USB 3.1 ENGINEERING CHANGE NOTICE

Title: Rx AC Coupling Capacitor Option Applied to: USB Specification Version 3.1

Figure 6-5. Channel Models

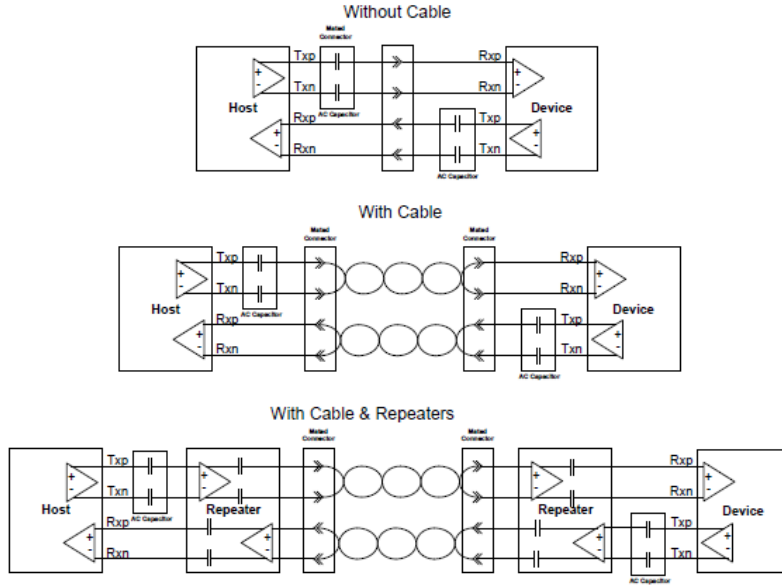
This ECN adds an AC coupling capacitor in RX side both host and device if need be. This is optional for some vendors.

Section 6.2, Figure 6-5 Channel Models, Page 161

Figure 6-5. Channel Models

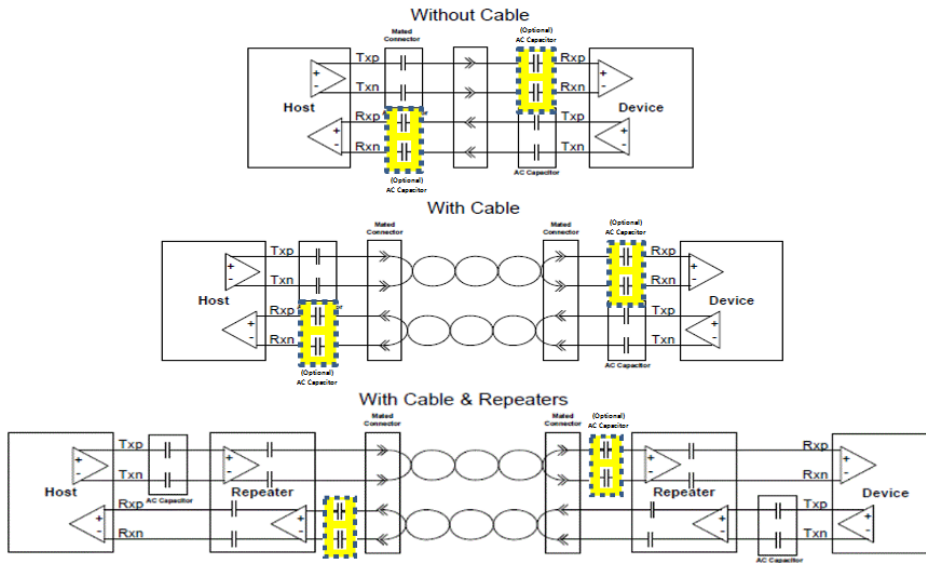
To Text:

This capacitor is useful for ESD/EOS protection and remove unwanted bias level from Rx side. Because RX side of different UBS-SS system have variable common mode voltage (use different termination scheme), this option can remove unmatched bias level for interconnection logic. After adding this capacitor leakage current through RX pin can be ideally 0mA and it is helpful to prevent water corrosion. (Same as TX side)

Total series capacitance can be slightly reduced. However combined value of 100nF (TX side) and 330nF (Optional RX side) can be meet minimum capacitance requirement for RX detection (75nF~265nF) and there is no expected effect.
